Final Report Technical Review of FEMA CCAMP for Ventura County

The County of Ventura

moffatt & nichol

August 2017

Figure 4-1: Wave Event from 2/24/08 Illustrating a Typical Wave Refraction Pattern (CDIP 2008)

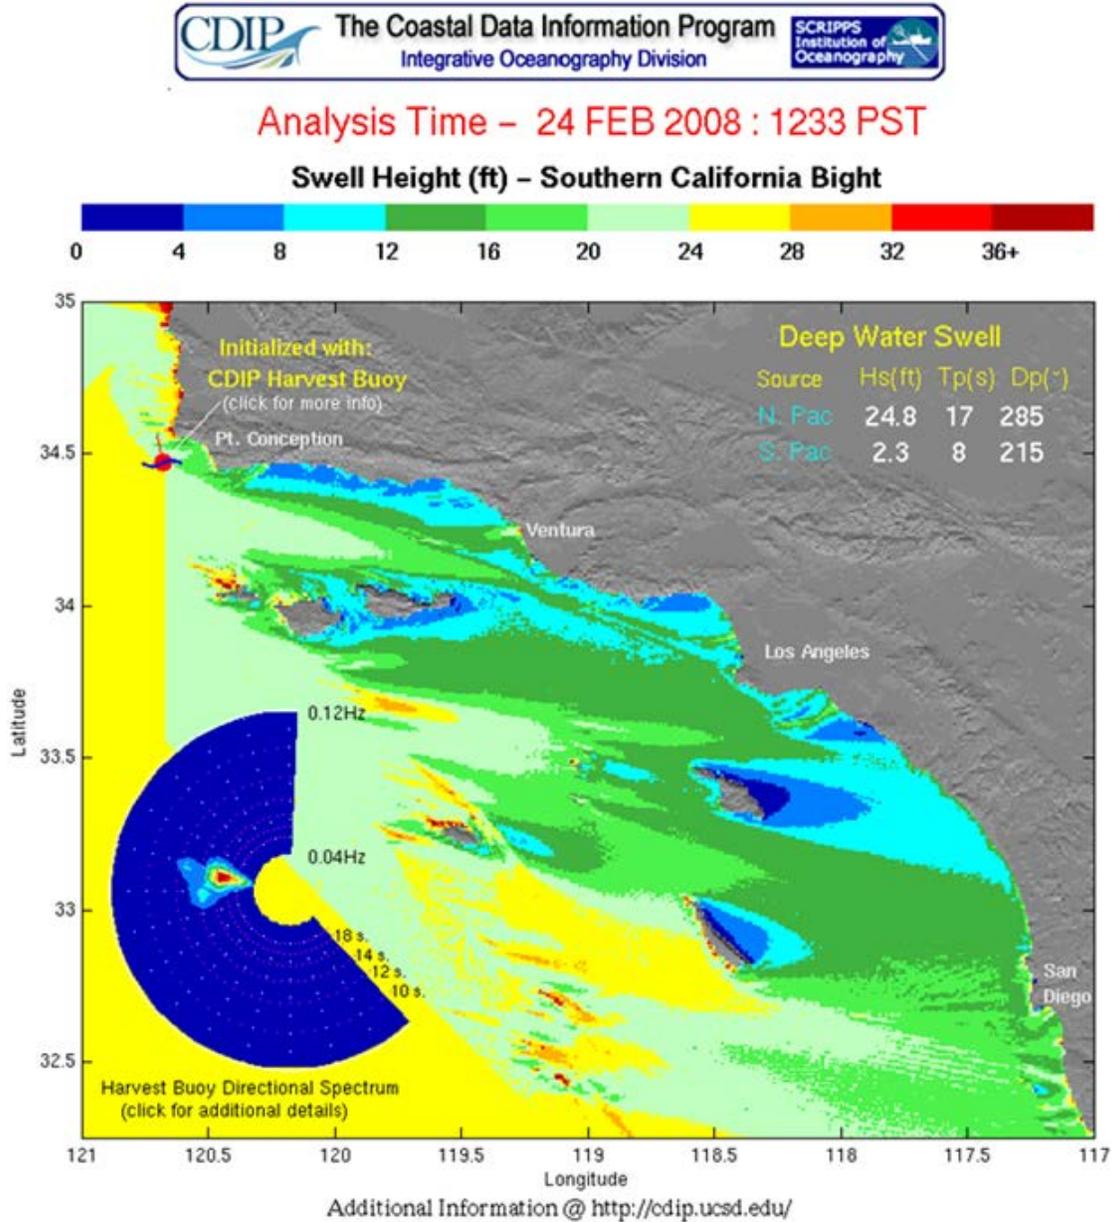
The patterns of TWL do not match the typical pattern of refracted waves inside the Santa Barbara channel. Looking at the BFEs across the County, reported values are higher along Rincon Parkway, smallest near Ventura Pier and small through the Oxnard plain. Figure 4-1 shows a large wave event (estimated as a 10-year event). The pattern of BFE should be close to this with the highest wave heights along the Santa Clara delta and sheltering along the Rincon Parkway. This pattern is not what the BFE elevations represent despite the use of the same CDIP Model Output Points.

Presently observed refraction patterns from example Figure 4-1 are not consistent with peak event wave characteristics from individual transects. This could result in both overestimates and underestimates of the BFE, depending on how the extreme events are characterized at each transect. The nearshore wave input and geomorphic slope parameters are key elements of the TWL calculations and vary widely between adjacent transects.

- 3. The pattern of BFE shall be close to the typical pattern of refracted waves inside the Santa Barbara channel.*

Figure 4-2: Excerpt of FEMA PFIRM Panel 06111C0884F

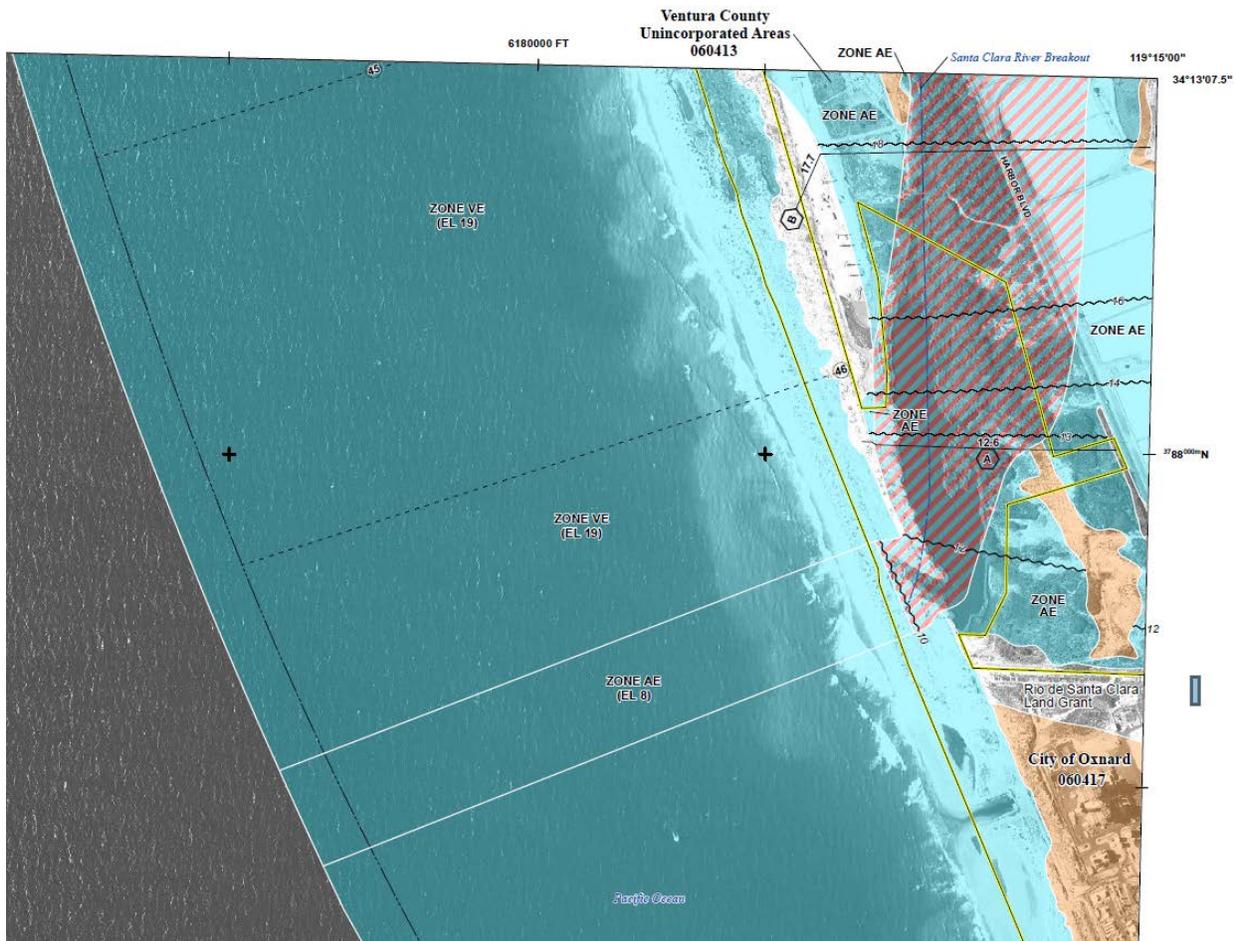
- a. At Santa Clara River mouth between Transects 44 and 45, and along the sandy beach south of the Santa Clara River between Transects 46 and 47, a strip of AE zone is shown without any technical support, interrupting the continuity of coastal flood hazard zones.
- b. Between transects 88 and 89, a new VE was shown without any supporting transect analysis.
- c. A VE zone south of transect 90 without supporting transect.

4. *Correct the AE zone mapping errors for coast between transects 44 and 45, and between 46 and 47. There are some odd discrepancies around the Rio de Santa Clara Land Grant where no coastal flood mapping has been identified despite the fact this area was flooded during the 1969 riverine flood event and is exposed to both riverine and coastal flood hazards (VE and AE zones shown in Figure 4-2).*

5. *Add transects to support the VE zone designations for coast between transects 88 and 89, and south of transect 90.*
6. *It is recommended that transects begin at a shallower depth around -15 to -20 m bathymetry contours instead of -40 m. Using wave parameters at the 40-m depth from the nearshore wave model as input parameters for the wave runup analysis is a poor choice for reaches with oblique wave approach angles and wave refraction. As some of the 2-D wave phenomena captured in the 2-D model cannot be captured in 1-D transect based analysis. These may lead to overestimate of the BFE. Please update the analysis.*

Figure 5-4: Transect 4/637 Profile and Runup Parameters

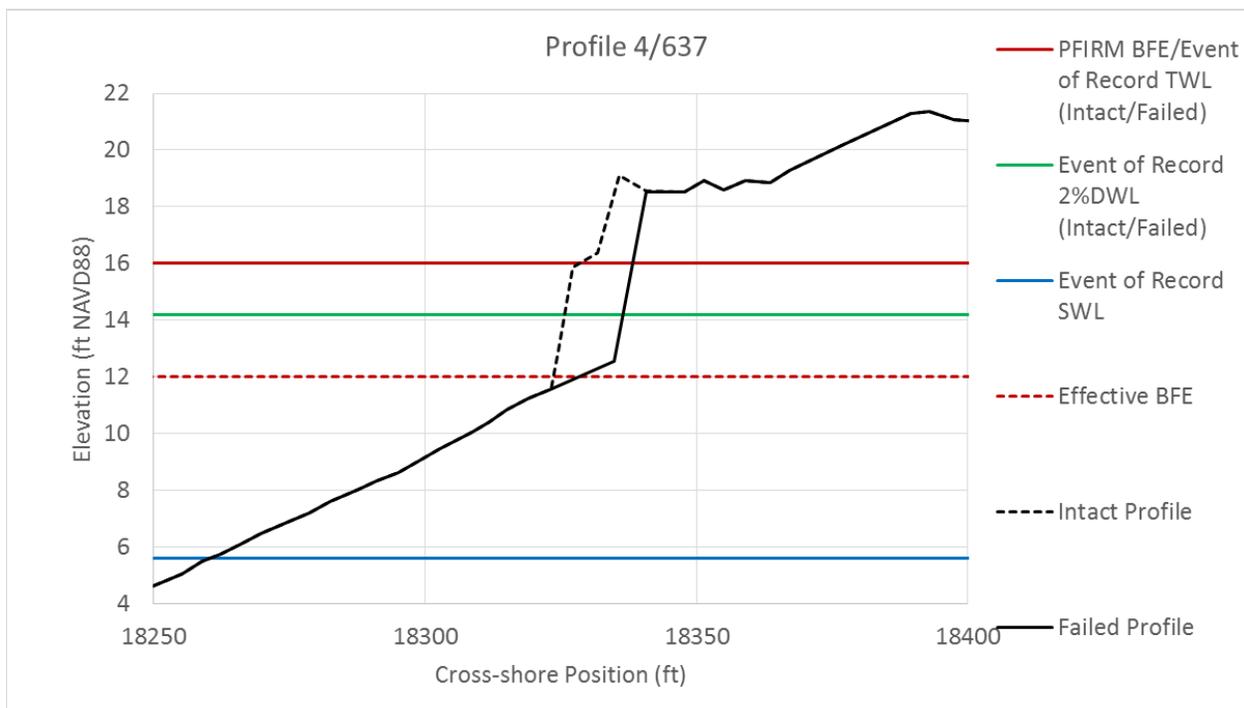
Transect 4 is located along a mild sloped dry sandy beach, which helps dissipate wave energy and reduce runup elevations, as shown in Figure 5-3. At this transect, it is assumed that waves will break on the sandy beach and the revetment/bluff crest at the back of the beach is not overtopped. If an eroded beach condition was assumed or the Most Likely Winter Profile was calculated, at this transect, waves would likely break on the back beach at the revetment (intact condition) or sandy bluff (failed condition) and wave runup would be greater and the BFE would increase. Runup parameters are shown on the transect profile in Figure 5-4 and further discussed in the following section.

- The runup slope used seems reasonable.
- Calculated TWL results were the same for both intact and failed conditions.

Figure 5-10: Transect 8/601 Profile and Runup Parameters

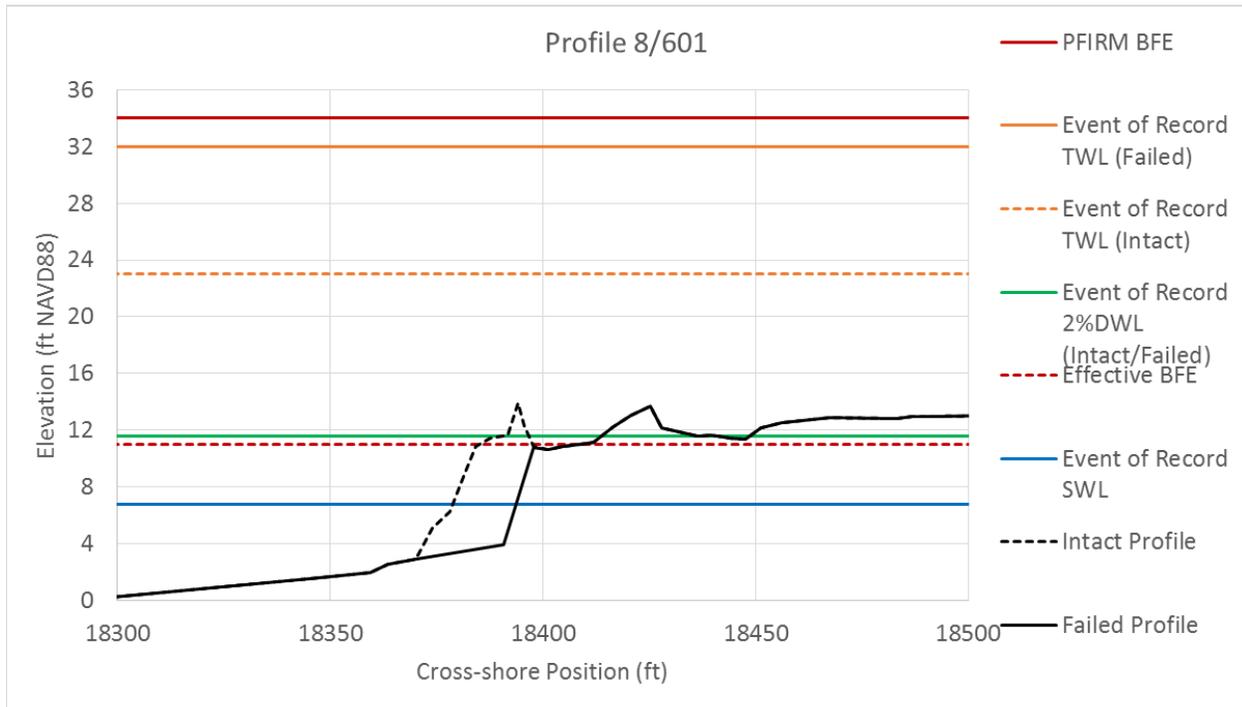
- Bore overtopping was calculated and mapped in a secondary VE zone at this transect since inland propagation exceeded 35 ft. If TWLs are reduced, overtopping would be recalculated and as a result, inland propagation and flood depths may be reduced.

An appeal may be warranted at Site 2 if the community wishes to challenge the BFE at Transect 8, on the basis of roughness reductions. Due to the longstanding existence of the rock revetment at this site a roughness factor should be applied to the failed revetment condition along this transect. If a reduction factor was applied the BFE could be lowered by 10%-20% at this transect. Overtopping would be recalculated with the reduced TWLs, which would reduce the inland extent and depth of the secondary VE zone. Modeling the revetment as intact, would provide an additional reduction in the BFE; however, regulations are stringent and as-built drawings, recent maintenance records, maintenance plans and other documentation would be required by FEMA. Additional study and calculations will be required for the appeal process.

Figure 5-19: Transect 11/568 Profile and Runup Parameters

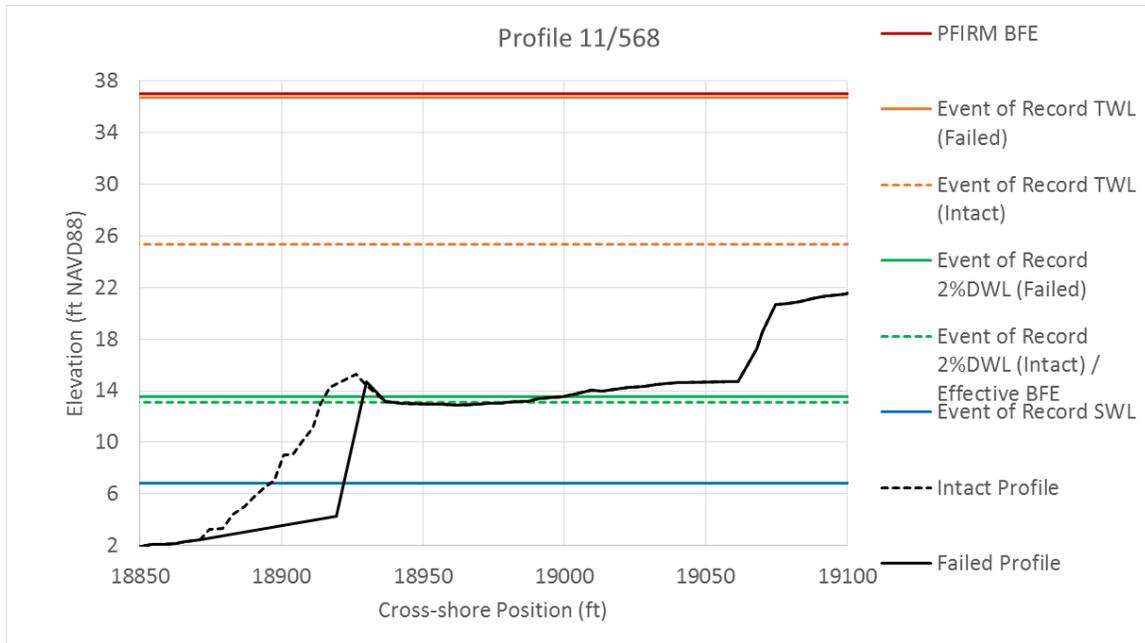
- Bore overtopping was calculated and mapped in a secondary VE zone at this transect since inland propagation exceeded 35 ft. If TWLs are reduced, overtopping would be recalculated and as a result, inland propagation and flood depths may be reduced.

Considering roughness could reduce the BFE by 10-20% at Transect 11. A lowered BFE would require overtopping to be recalculated and may reduce the depth and extent of the secondary VE zone. Modeling the revetment as intact would provide an additional reduction in the BFE; however, FEMA regulations are stringent and as-built drawings, maintenance records, maintenance plans and other documentation would be required.

Figure 5-20: Transect 12/567 Profile and Runup Parameters

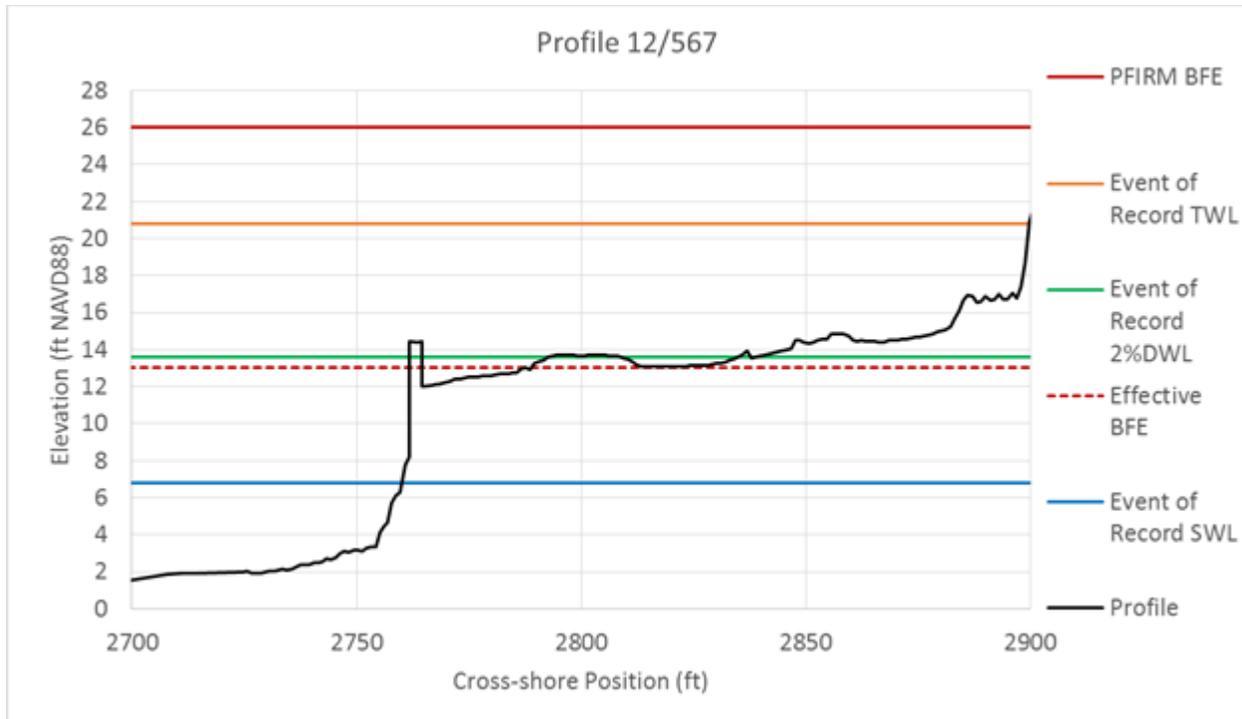
- BFE (26 ft NAVD88) exceeds the event of record TWL (20.8 ft NAVD88 1/18/88).
- SWL of 6.8 ft NAVD88 is the same as Transect 11, H_o of 14.6 ft is 12% less than Transect 11, and T_p of 15.9 seconds is the same as Transect 11.
- Wave approach angle is oblique and may warrant a small TWL reduction.
- SWL is above toe; therefore, TAW runup method is appropriate.
- Transect geometry includes a vertical face of a seawall. The condition and maintenance of this structure is unknown, and it may not be representative of the entire zone where some seawalls have a recurved face.
- Aerial imagery shows the presence of cobble, rock, and sand at the base of seawalls. There may be potential for a small TWL reduction if a revised roughness factor is

Figure 5-22: Transect 14/561 Profile and Runup Parameters

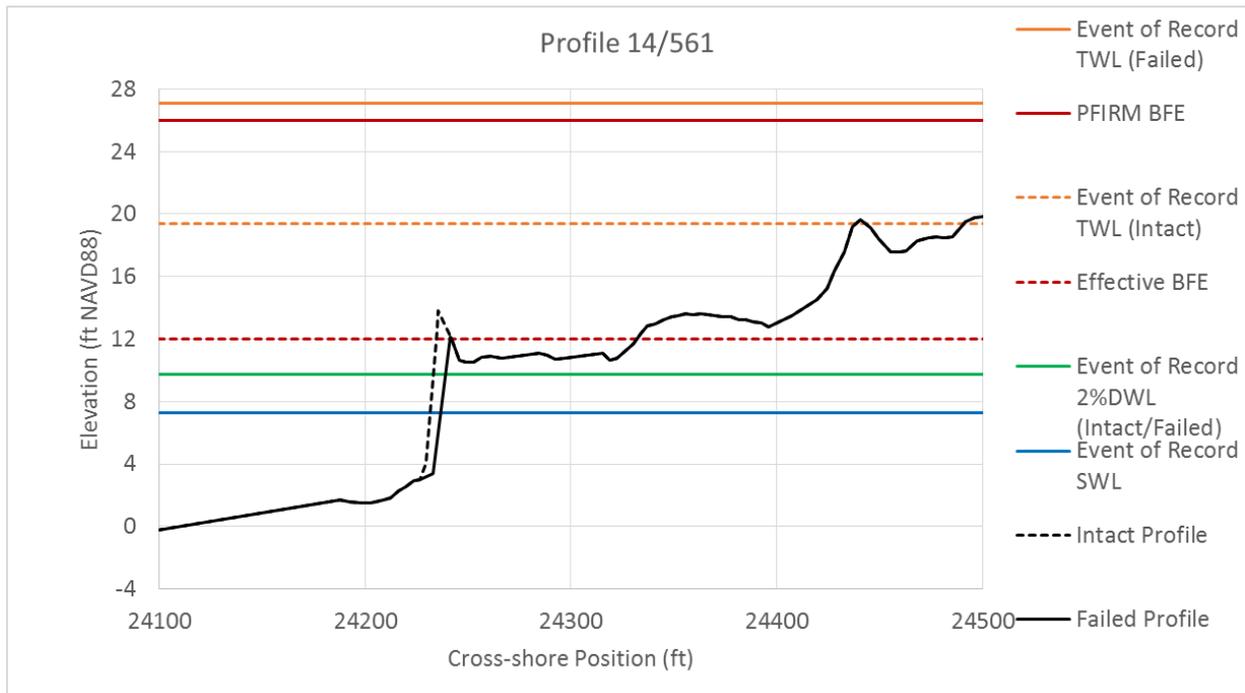
- Aerial imagery shows the presence of rock, cobble, and sand at this transect. There may be potential for a small TWL reduction if a revised composite roughness reduction factor is considered for the failed condition.

Figure 5-24: Transect 16/554 Profile and Runup Parameters

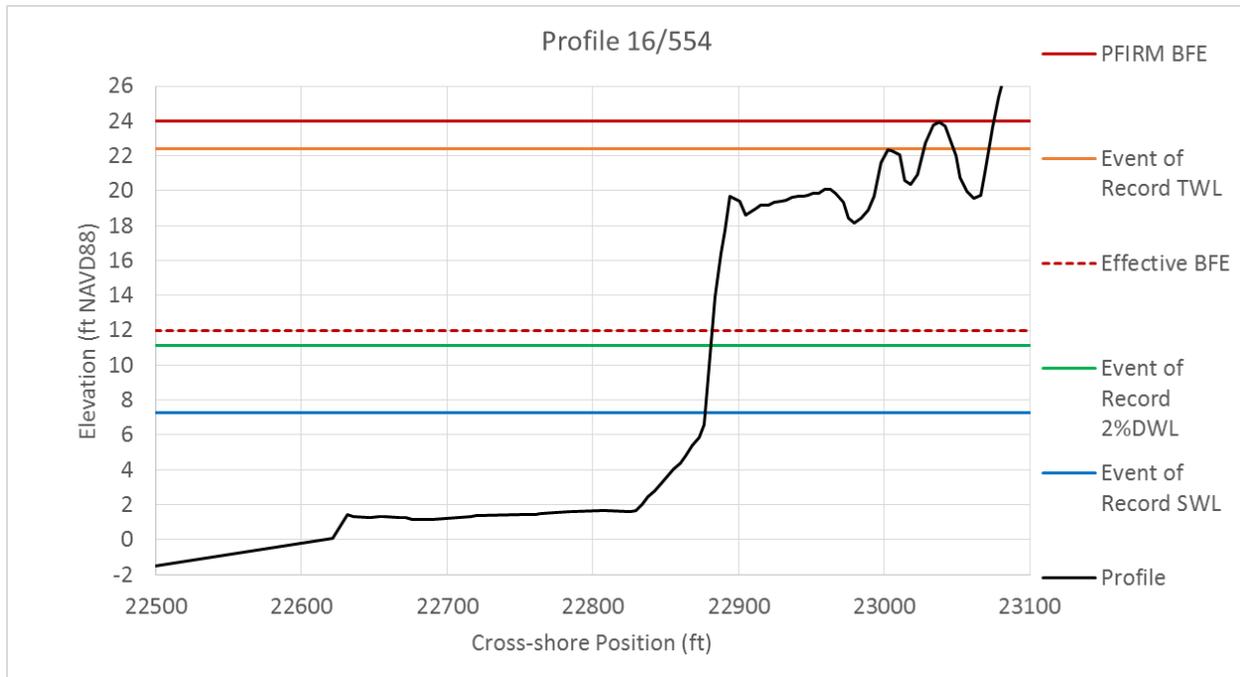
- Splash overtopping was calculated and mapped in the primary VE zone at this transect since inland propagation was less than 35 ft. If TWLs are reduced, overtopping would be recalculated and as a result, inland propagation may be reduced.

Using a composite roughness factor could reduce the BFE by 10-20% at Transects 16 & 18. An appeal could lead to a revised modeling approach of the revetment along this reach, which may raise the BFE.

Figure 5-26: Transect 18/546 Profile and Runup Parameters

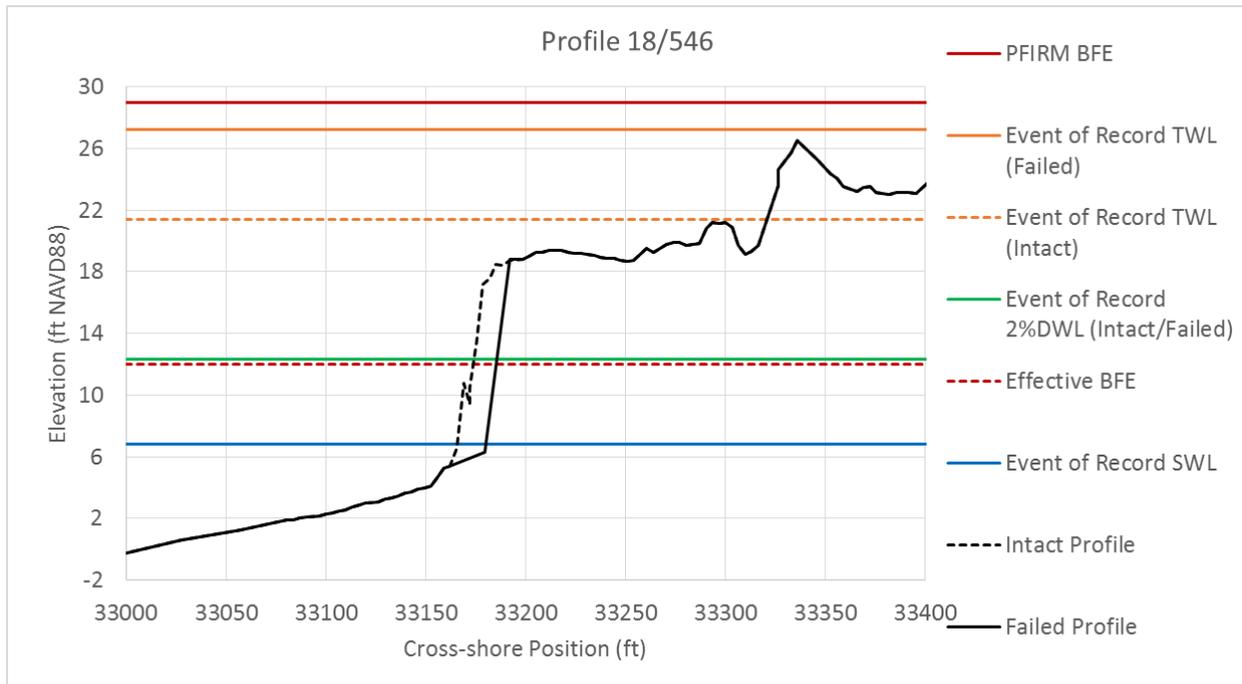
- Bore overtopping was calculated and mapped in the primary VE zone at this transect since inland propagation was less than 35 ft. If TWLs are reduced, overtopping would be recalculated and as a result, inland propagation may be reduced.

Figure 5-27: Transect 19/539 Profile and Runup Parameters

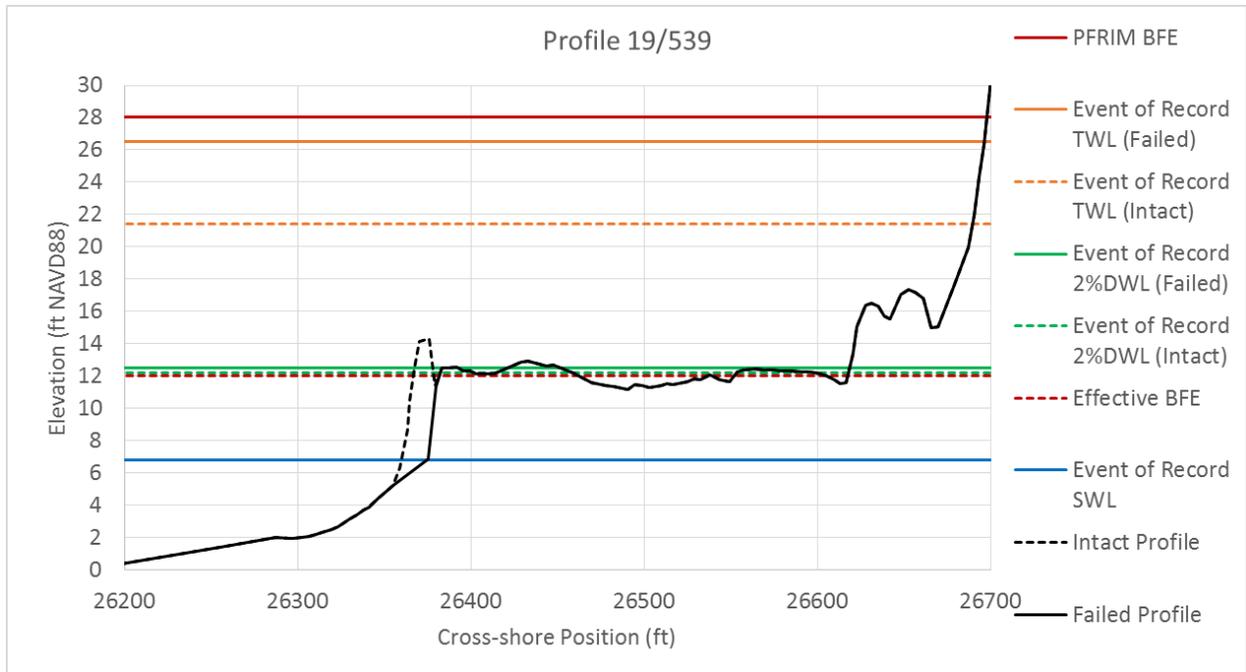
- Bore overtopping was calculated and mapped in a secondary VE zone at this transect since inland propagation exceeded 35 ft. If TWLs are reduced, overtopping would be recalculated and as a result, inland propagation and flood depths may be reduced.
